Product Change Notification / SYST-04AEAI643

ERRATA - dsPIC33EPXXXGS70X/80X Family Silicon Errata and Data Sheet Clarification

dsPIC33EPXXXGS70X/80X Family Silicon Errata and Data Sheet Clarification

FIGURE 1:

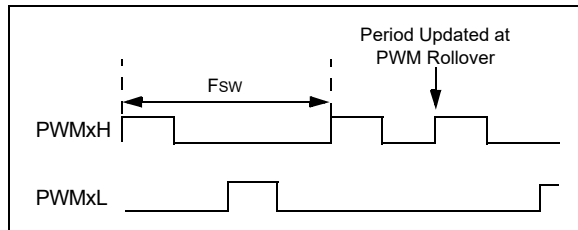
When the PWM module is configured for Push-Pull mode ($IOCONx[11:10] = 0b10$) with the Enable Immediate Period Update bit enabled ($PTCON[10] = 1$), a write to the Period register that coincides with the period rollover event may cause the push-pull output logic to produce back-to-back pulses on the PWMx pins (see Figure 1).

Ensure that the update to the PWM Period register occurs away from the PWM rollover event by setting the EIPU bit ($PTCON[10] = 1$). Use either the PWM Special Event Trigger (SEVTCMP) or the PWM Primary Trigger (TRIGx) to generate a PWM Interrupt Service Routine (ISR) near the start of the PWM cycle. This ISR will ensure that period writes do not occur near the PWM period rollover event.

FIGURE 2: EXAMPLE FOR REDUNDANT OUTPUT MODE

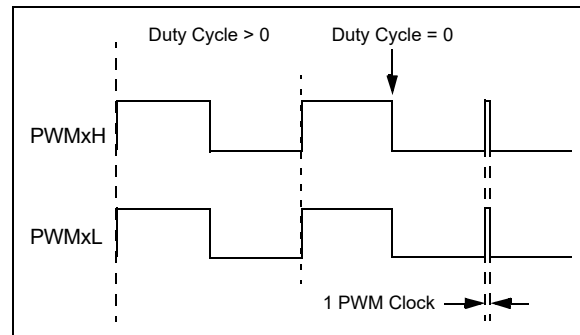
In the Redundant Output mode ($IOCONx[11:10] = 0b01$) and Push-Pull Output mode ($IOCONx[11:10] = 0b10$), with the Immediate Update Enable bit disabled ($PWMCONx[0] = 0$), when the Duty Cycle register is updated from a non-zero value to zero, a glitch pulse of a width equal to 1 PWM clock will appear at the next PWM period boundary, as shown in Figure 2 (for the Redundant Output mode). The Duty Cycle register refers to the PDCx register if $PWMCONx[8] = 0$ or the MDC register if $PWMCONx[8] = 1$.

If the application requires a zero duty cycle output, there are two possible work around methods:

1. Use the PWM override feature to override the PWM output to a low state instead of writing to the Duty Cycle register. In order to switch back to a non-zero duty cycle output, turn off the PWM override. The override-on and override-off events must be timed close to the PWM period boundary if the $IOCONx$ register has been configured with $IOCONx[0] = 0$ (i.e., output overrides through the $OVRDAT[1:0]$ bits occur on the next CPU clock boundary).
2. Enable the Immediate Update Enable bit ($PWMCONx[0] = 1$) while configuring the PWMx module (i.e., before enabling the PWMx module, $PTCON[15] = 1$). With the Immediate Update enabled, writes to the Duty Cycle register can have an immediate effect on the PWM output. Therefore, the duty cycle write operations must be timed close to the PWM period boundary in order to avoid distortions in the PWM output.

FIGURE 3: SIMPLIFIED BEHAVIOR

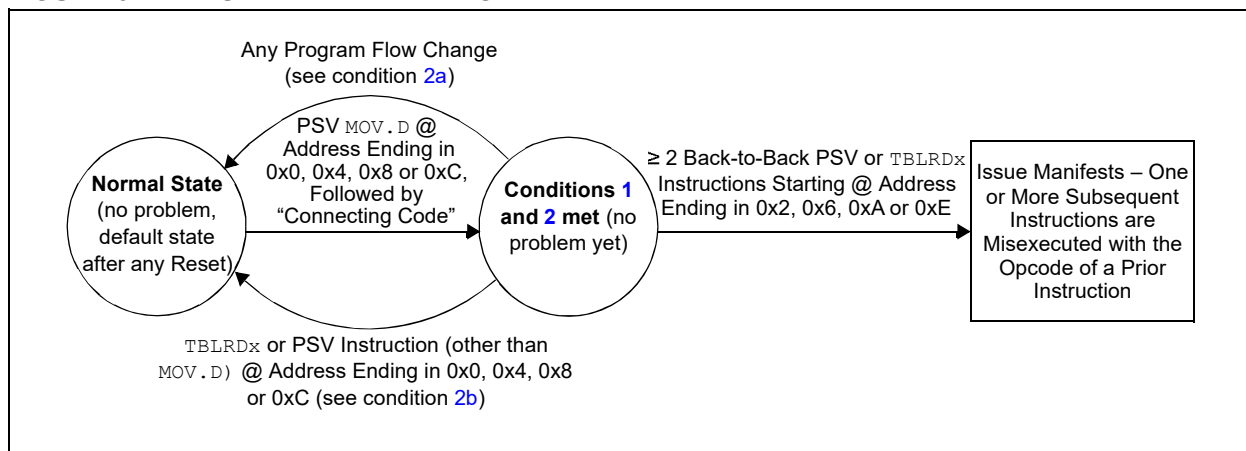
When two or more data Flash read instructions (via Program Space Visibility (PSV) read or Table Read) are executed back-to-back, one or more subsequent instructions can be misexecuted when all of the conditions in [Table 4](#) occur.

1.	A PSV <code>MOV.D</code> instruction is executed, with opcode at address ending in 0x0, 0x4, 0x8 or 0xC; and
2.	Some “connecting code” is executed (following the <code>MOV.D</code> of condition 1), with the properties: <ul style="list-style-type: none"> a) The connecting code does not include any program flow changes, including: taken branch instructions (including all versions of <code>BRA</code>, <code>CPBEQ</code>, <code>CPBGT</code>, <code>CPBLT</code>, <code>CPBNE</code>), <code>CALL</code>, <code>CALL.L</code>, <code>GOTO</code>, <code>GOTO.L</code>, <code>RCALL</code>, <code>RETLW</code>, <code>RETURN</code>, vectoring to an ISR, returning from an interrupt (<code>RETFIE</code>) and certain debug operations, such as break and one-step; and b) The connecting code does not include a <code>TBLRDx</code> or non-<code>MOV.D</code> PSV instruction, located at a Flash memory address ending in 0x0, 0x4, 0x8 or 0xC; and c) The connecting code is at least two instruction words in length; and d) The connecting code does not end with a <code>REPEAT</code> instruction, with count > 0; and

3.	≥ 2 back-to-back PSV or <code>TBLRDx</code> instructions are executed (following the code of condition 2), where the first of the back-to-back instructions is located at an address ending in 0x2, 0x6, 0xA or 0xE.

The issue can be avoided by ensuring any one or more of the requirements are not met. For example:

1. All instances of PSV `MOV.D` can be replaced with two PSV `MOV` instructions instead. Non-PSV `MOV.D` instructions acting on RAM/SFRs do not need to be modified; or
2. If not already present, a program flow change instruction (such as `BRA $+2`) can be inserted above back-to-back data Flash read sequences; or
3. Back-to-back data Flash read instruction sequences can be broken up by inserting a non-Flash read instruction (such as a `NOP`), in between the Flash read instructions; or
4. The alignment of the code can be shifted to avoid the required opcode location addresses.

FIGURE 4-2: PROGRAM MEMORY MAP FOR dsPIC33EP128GS70X/80X DEVICES

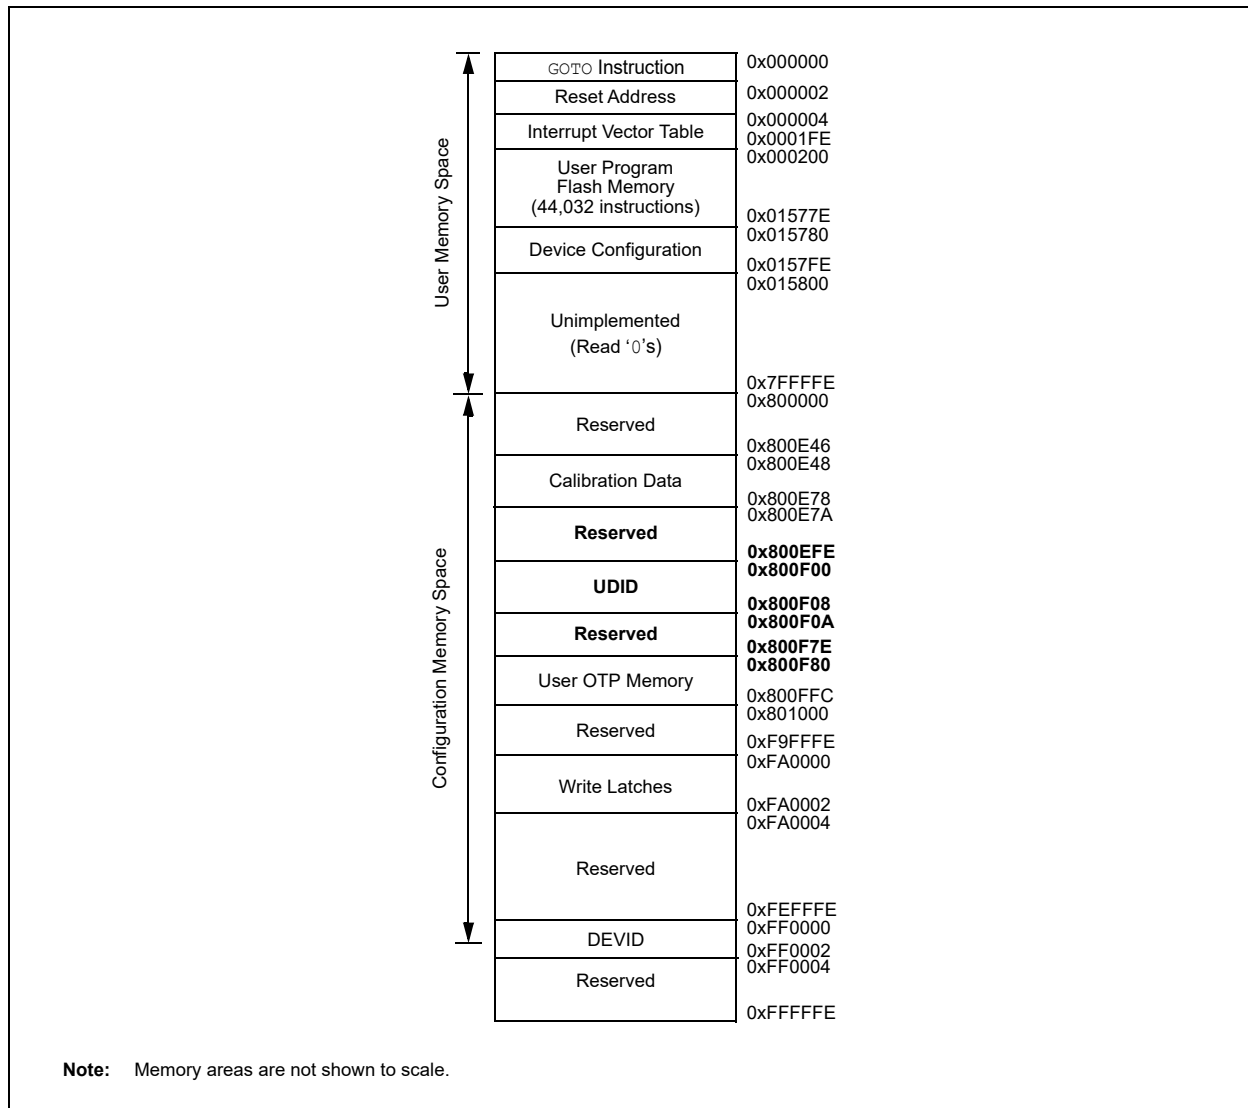
In Figure 4-2, the following changes have been made as shown in **bold**:
